# Federal Aviation Administration

Subject: Lawrence Airport (LWC), Lawrence, KS. Parachute Landing Area Assessment

Subject: Request for Safety Determination, Informal Complaint, Mr. William  
McCauley

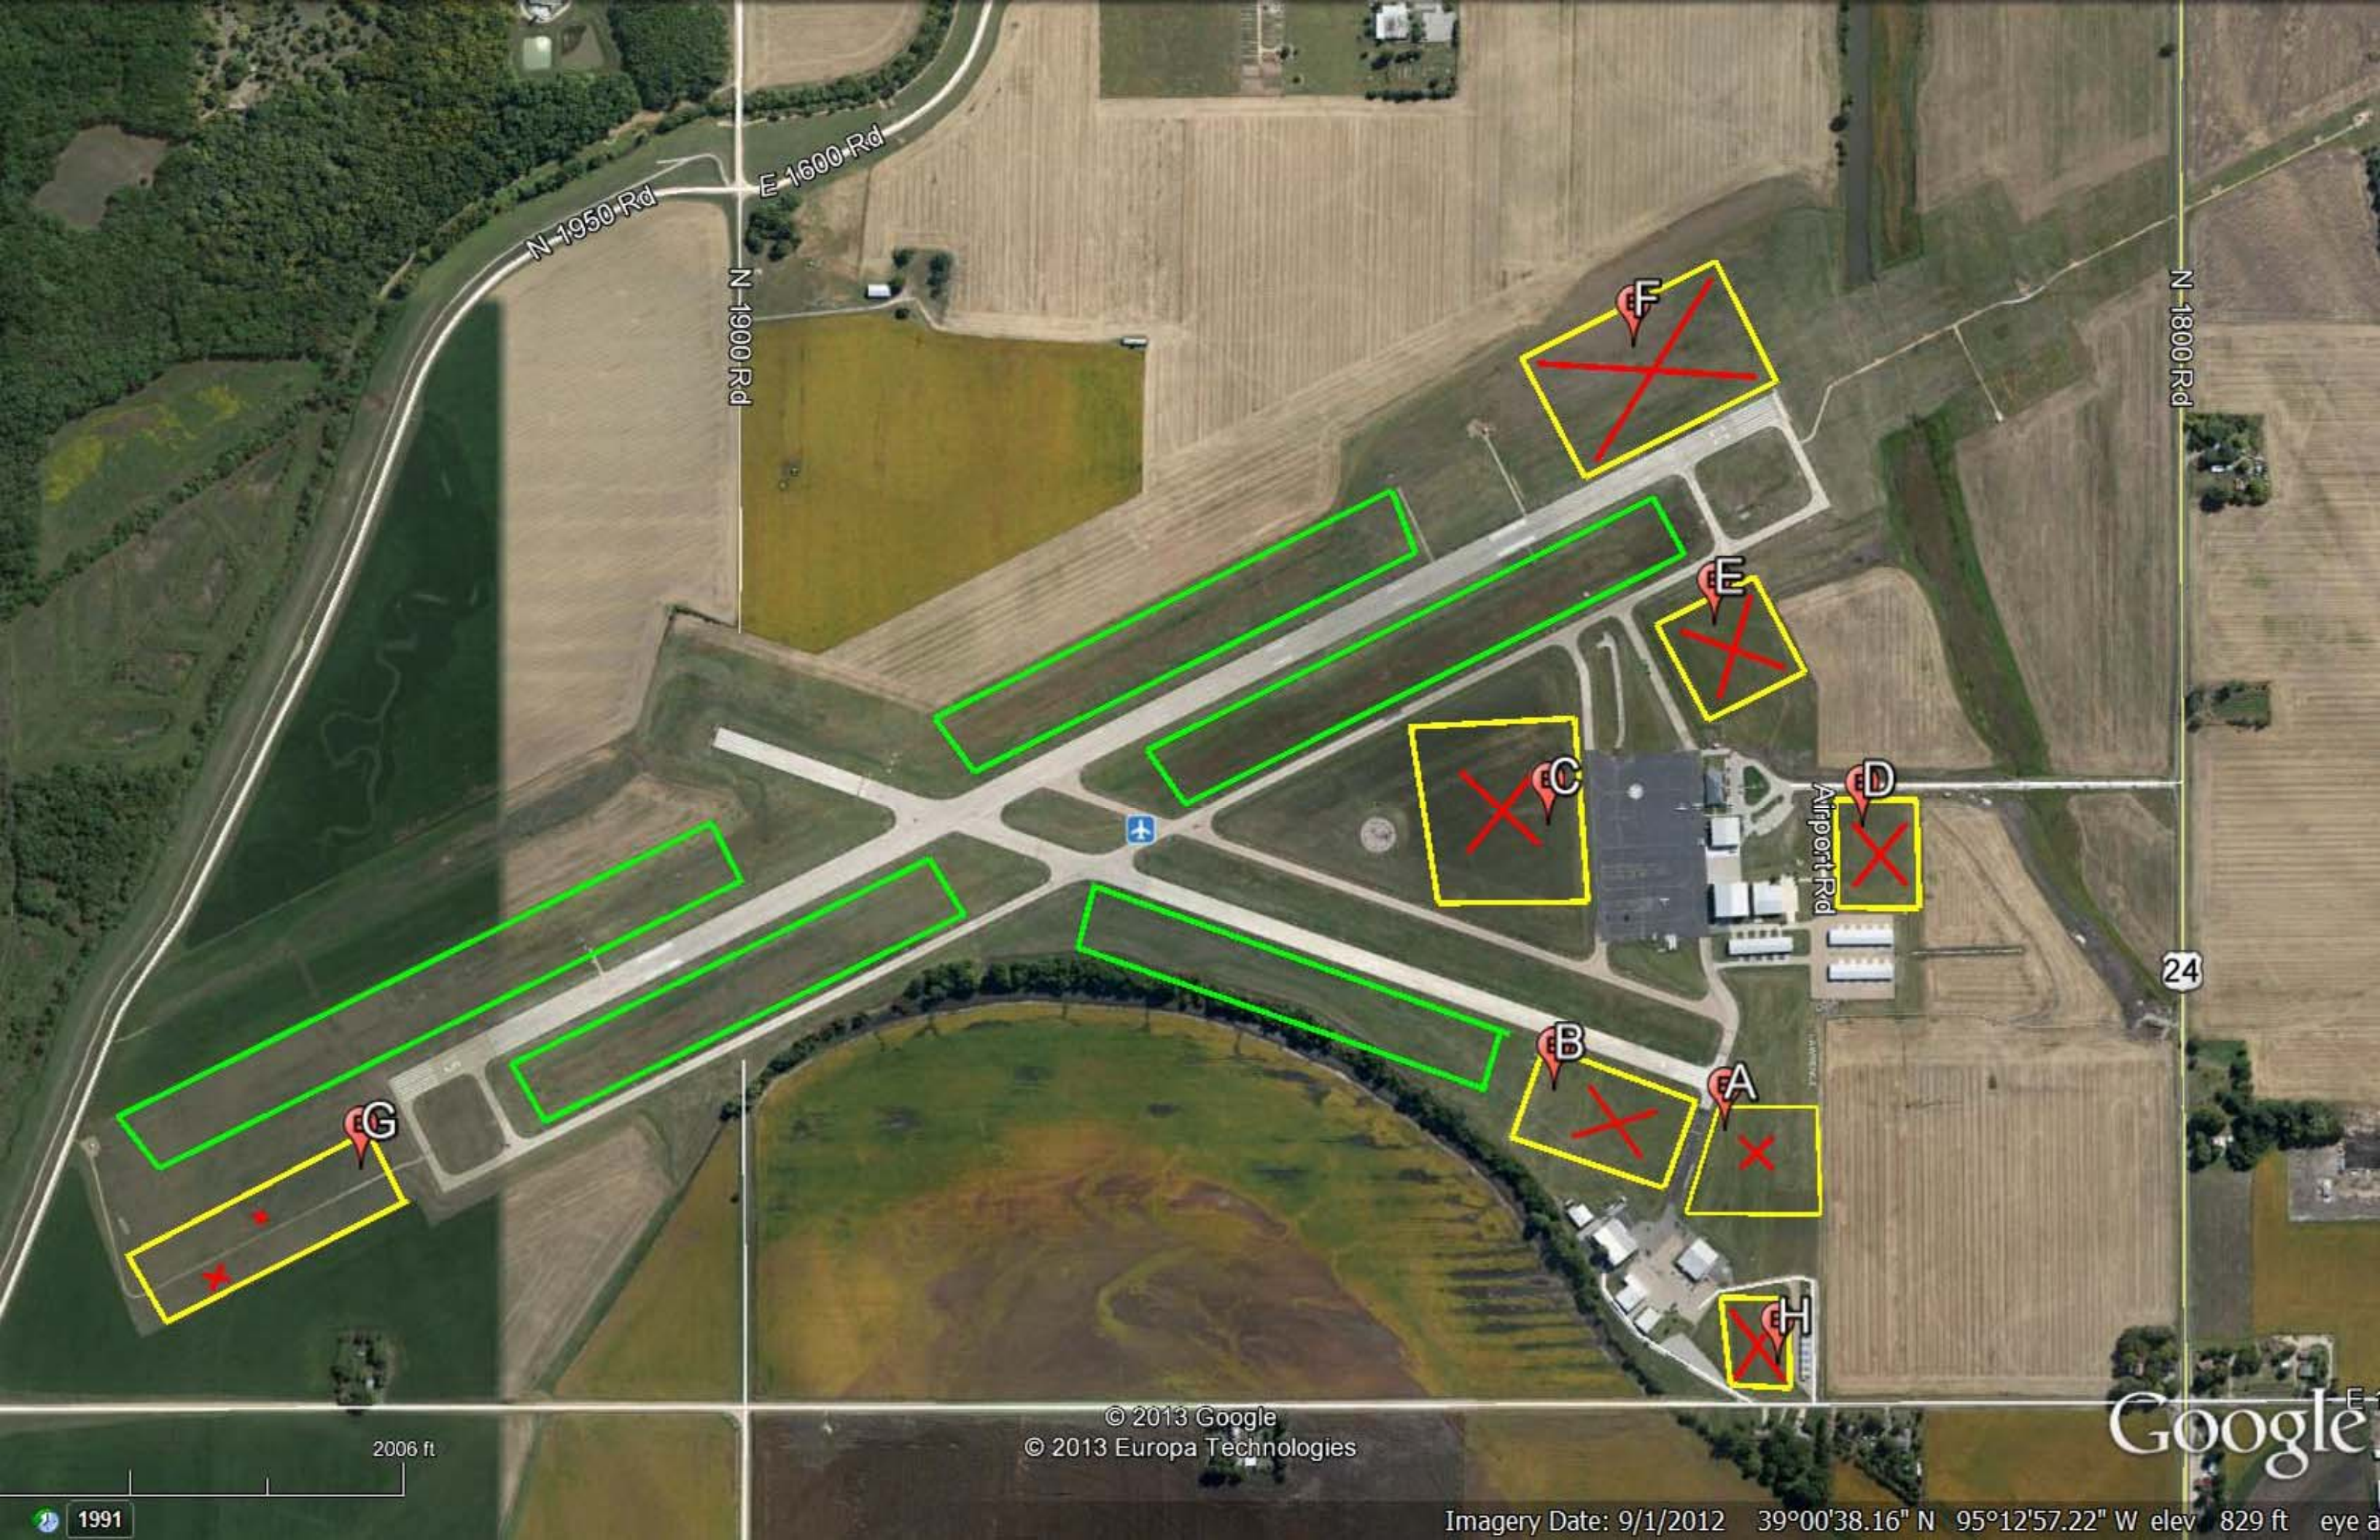
As requested by the FAA Office of Airports Division (ACO-100, Gabriel Mahns) and the General Aviation and Commercial Division (AFS-800), a desk audit (an examination of documents that is done off site) of proposed parachute landing areas on Lawrence Airport (LWC) was conducted by Mike Millard (AFS-830). Using the proposed parachuting landing area diagram (attached) and Google Earth measuring tools to evaluate if eight (8) proposed locations on the airport (lettered A-H) have adequate space to accommodate the parachute operations.

Upon review of the information gathered during the desk audit assessment, it is determined that three (3) of the proposed parachute landing areas will accommodate US Parachute Association B, C, D license holders, and Tandem parachute operations. The three acceptable areas are C, D, or E, with area C being considered the best option because of its location and size.

Utilizing any of the three proposed parachute landing area's (C, D, or E) provides risk mitigation by placing approximately four tenths (.4) of a mile between the parachute landing area and the airports life flight helicopter operation based on the airport. The size of the proposed landing areas can accommodate US Parachute Association B, C, D license holders, and Tandem parachute operations, while limiting Solo Student and A license holders. This provides risk mitigation by having more experienced and accurate skydivers utilizing the parachute landing area. Additional risk mitigation will be established by developing a plan to incorporate the provision established by the Wichita FSDO safety review.

As previously identified during the Wichita Flight Standards District Office (FSDO) safety review on February 3, 2010, skydive operations can be supported on the airport provided certain provisions are met (see attached). A plan needs to be developed to implement the identified provisions before operations begin.
